ADMINISTRATIVE DEVELOPMENT PLAN AMENDMENT  
 FILE NO. AA-02236-2012  
 3/19/02  
 PLANNING DIRECTOR DATE

Cottonwood Trails

SITE PLAN FOR SUBDIVISION AND BUILDING PERMIT

Consensus Planning January 10, 2001 Revised: February 13, 2002 Sheet 1 Of 8

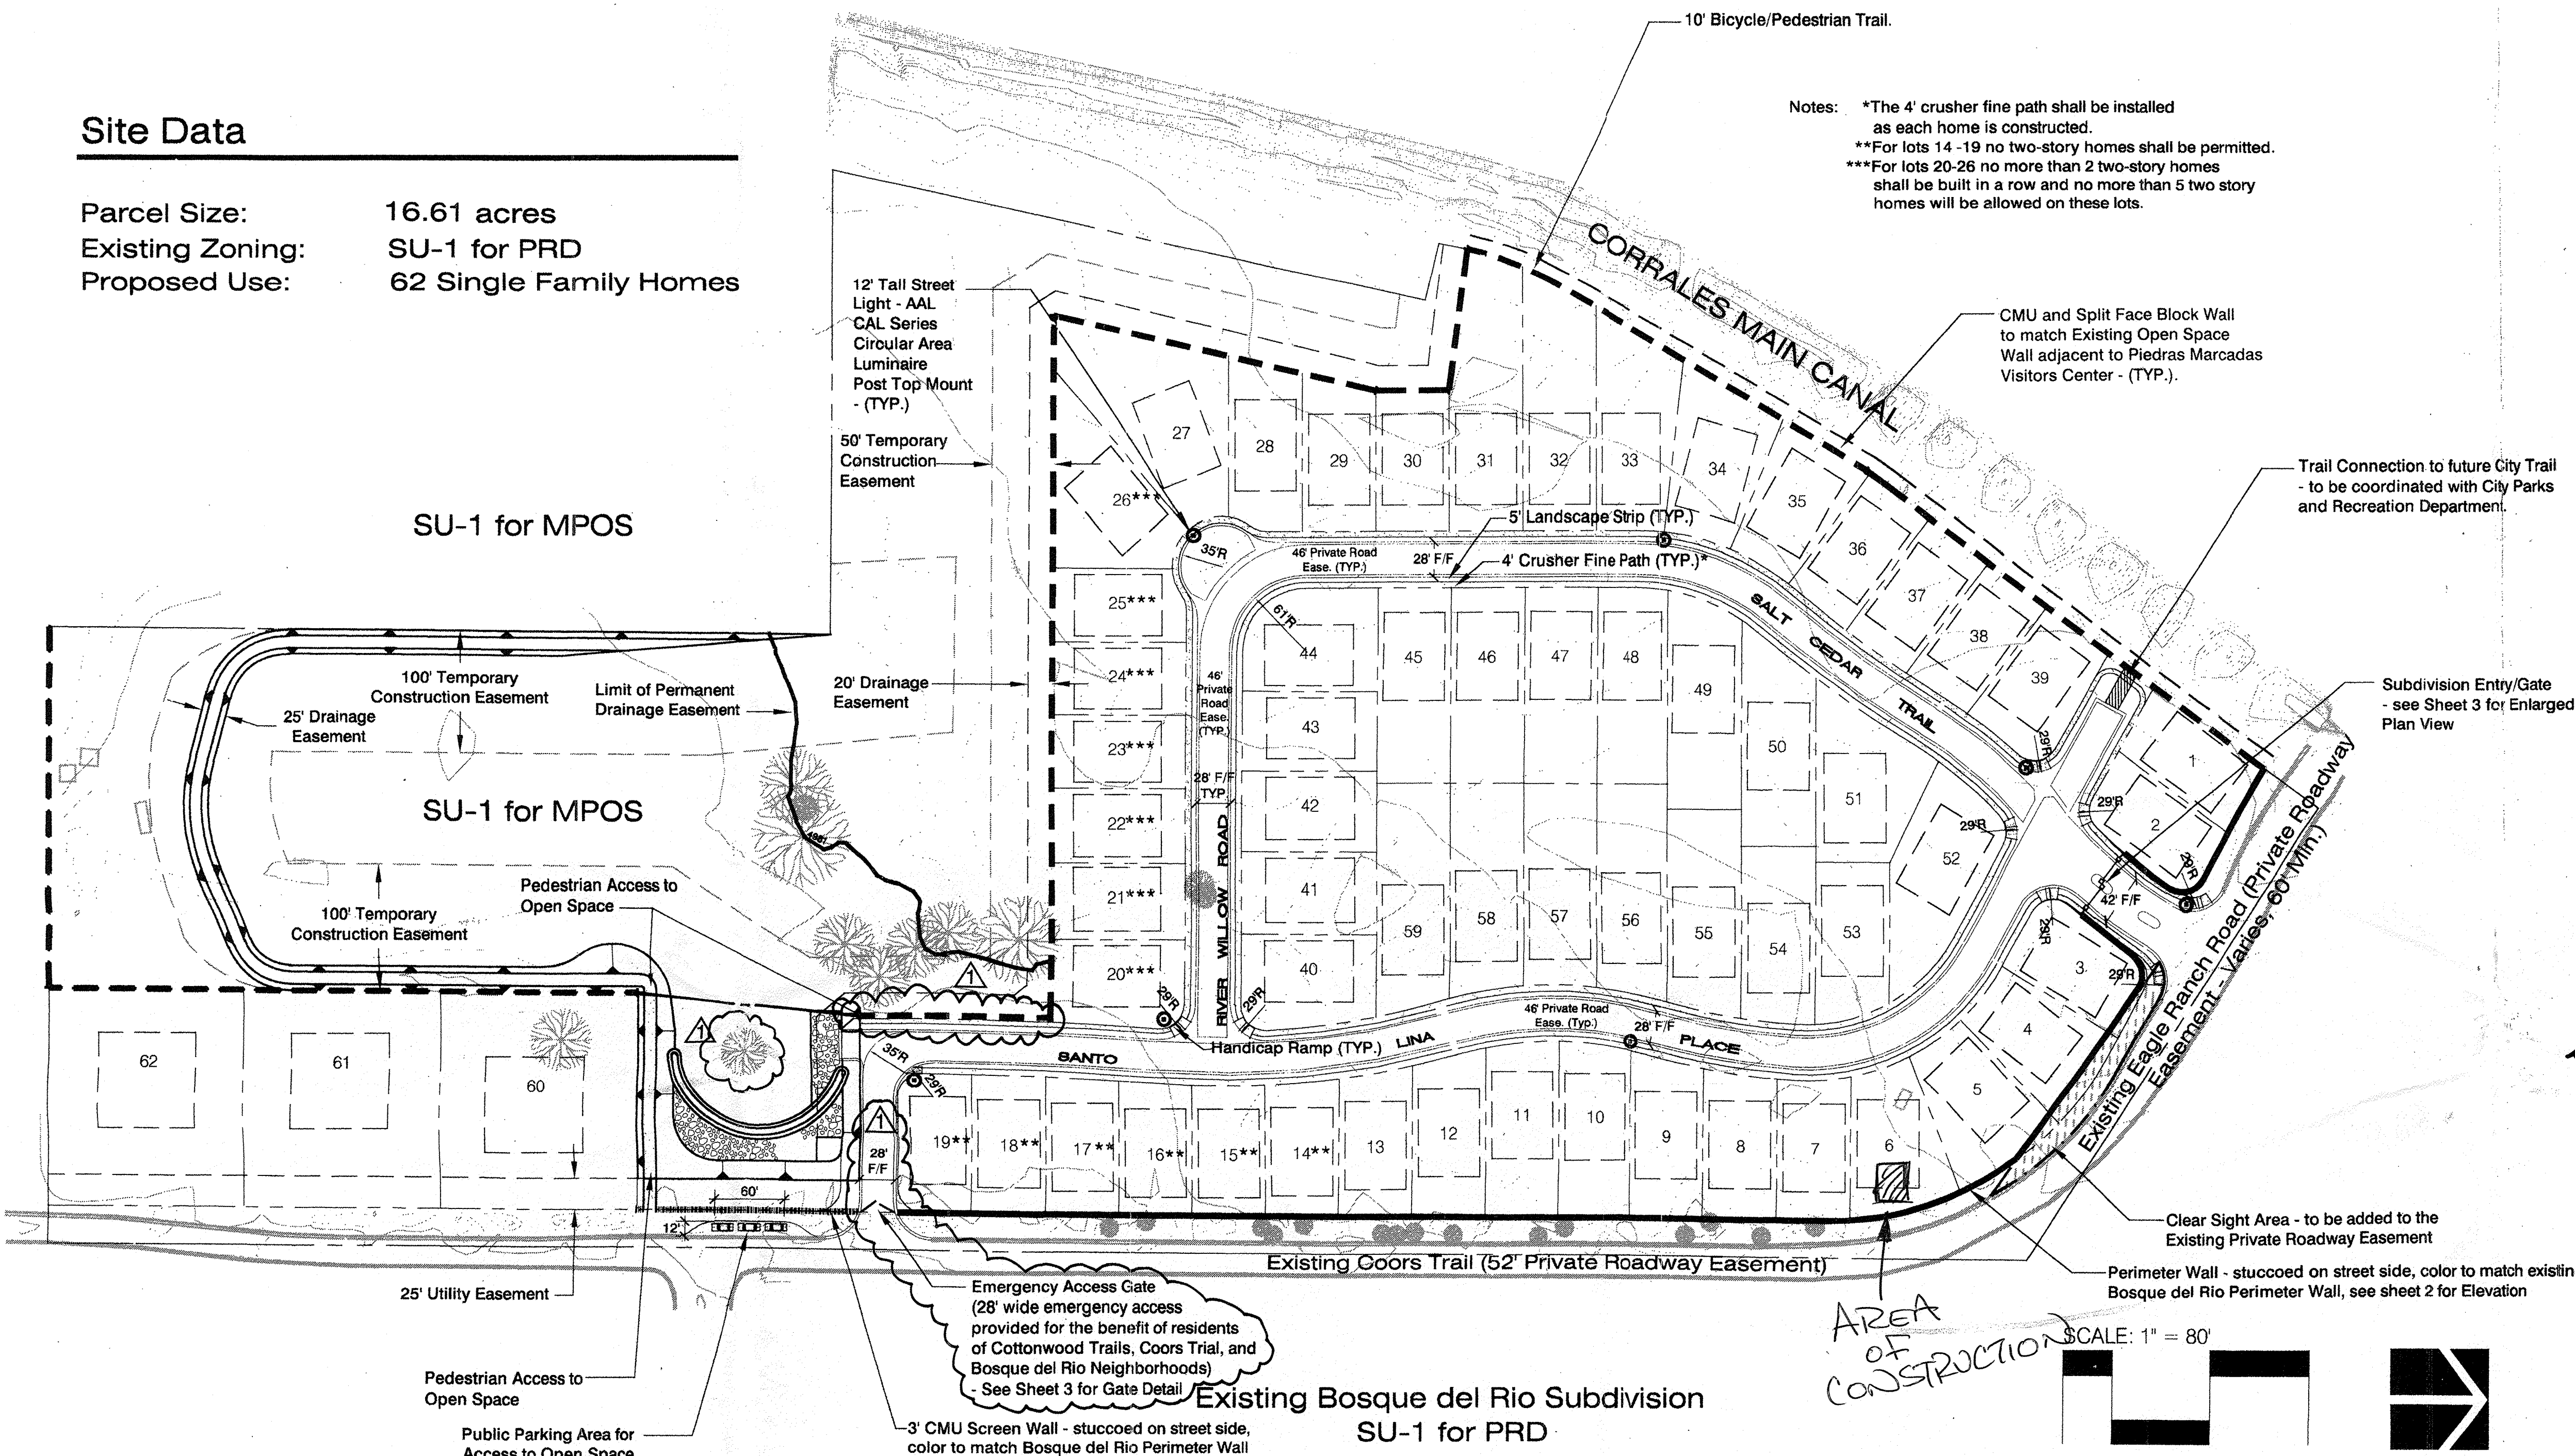
- Revised wall adjacent to City Open Space (Lots 18-26 & 60-62) to allow wrought iron view fencing (see new Sheet 3B).
- Added section of Open Space wall along the west side of Santo Lina Place (see Sheet 1).
- Revised note regarding existing cottonwood in the detention pond (see Sheets 2 & 3).
- Added Sheet 3B, Open Space Wall/Fence Plan.
- Modified Emergency Access per City DRC requirements (see Sheet 3).
